PNP 2011-002

SUBJECT: License Amendment Request for Spent Fuel Pool Region I Criticality

Palisades Nuclear Plant
Docket 50-255
License No. DPR-20

ATTACHMENT 1
DESCRIPTION AND EVALUATION OF REQUESTED CHANGE

Region 1B Patterns for Four or Fewer Face Adjacent Assemblies in a Row
 Two in a Row Three in a Row Four in a Row

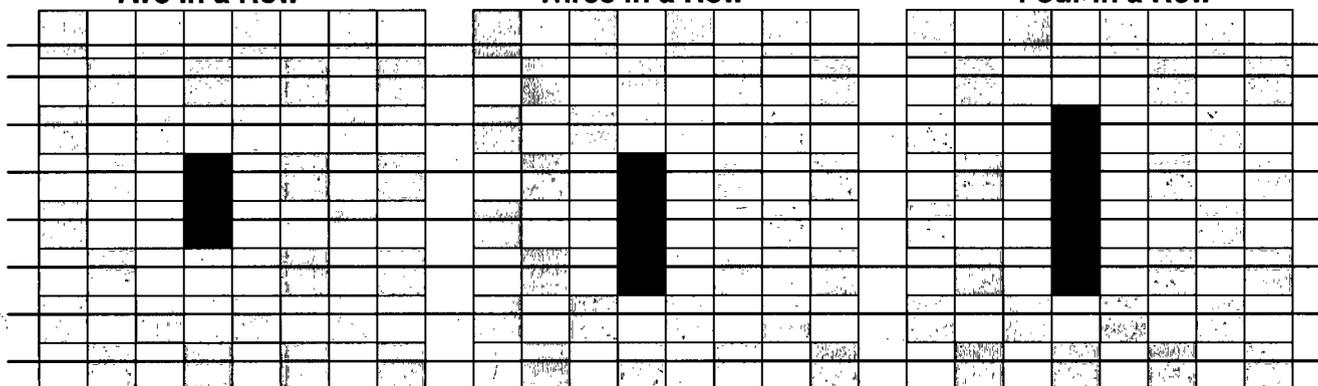
g. Region 1B is defined as the Region I storage racks located in the main spent fuel pool with face adjacent fuel that is surrounded by empty face adjacent cells. Region 1B fuel is limited to those assemblies having a nominal planar average U-235 enrichment of less than or equal to 4.34 weight percent. Region 1A cells that are diagonally adjacent to Region 1B may contain fuel assemblies provided conditions of Section 4.3.1.1f, 4.3.1.1g.1 and 4.3.1.1g.2 are met. Restrictions for non-fissile bearing components are described in section 4.3.1.1j below. Additional geometric conditions on Region 1B are:

1. Up to four face adjacent fuel assemblies in a single contiguous row are allowed as shown in the figures below. All other face adjacent cells shall be empty or contain non-fissile bearing components as described in section 4.3.1.1j below.

Region 1B Patterns for Three in an L

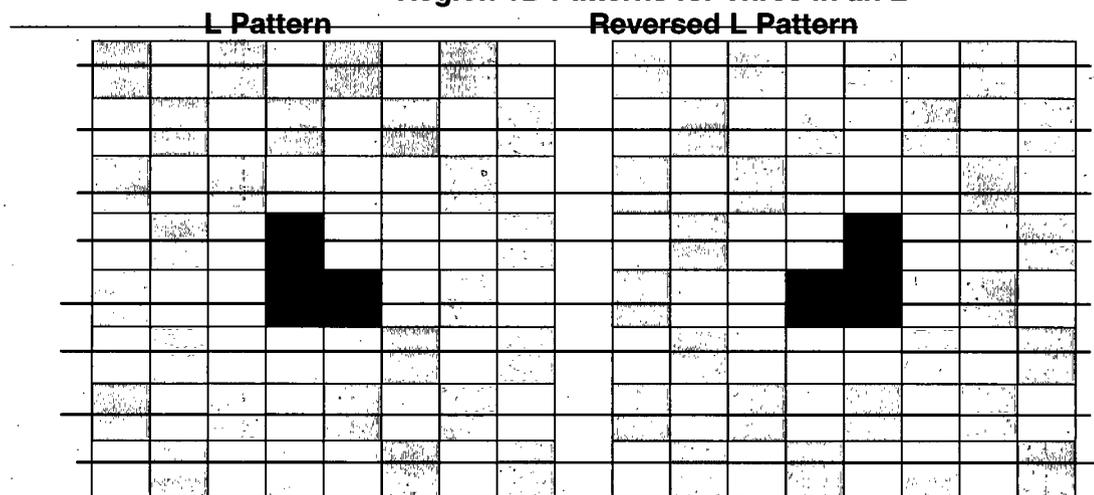
2. Three face adjacent fuel assemblies forming an L pattern are allowed as shown in the figures below. All face adjacent cells surrounding the two by two block containing the L pattern shall be empty or contain non-fissile bearing components as described in section 4.3.1.1j below;

Region 1E Allowed Fuel Storage Pattern

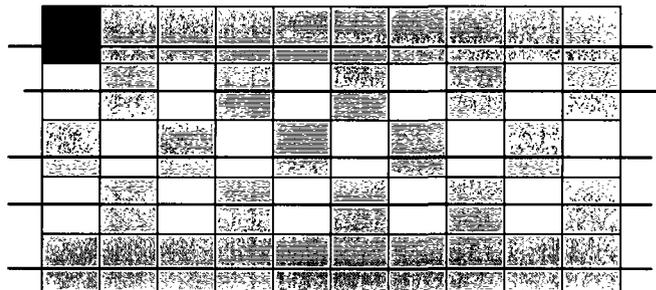
- i. Region 1E is defined as the Region I storage rack located in the north tilt pit. Region 1E shall maintain the selective loading pattern as shown in the figure below. This selective loading pattern allows for one fuel assembly having a nominal planar average U-235 enrichment of less than or equal to 3.26 weight percent. This assembly shall be placed in the southwest corner location of the rack. All 34 other allowed fuel locations in the figure below are limited to a nominal planar average U-235 enrichment of less than or equal to 3.05 weight percent. The remaining fifteen cells shall be empty; and
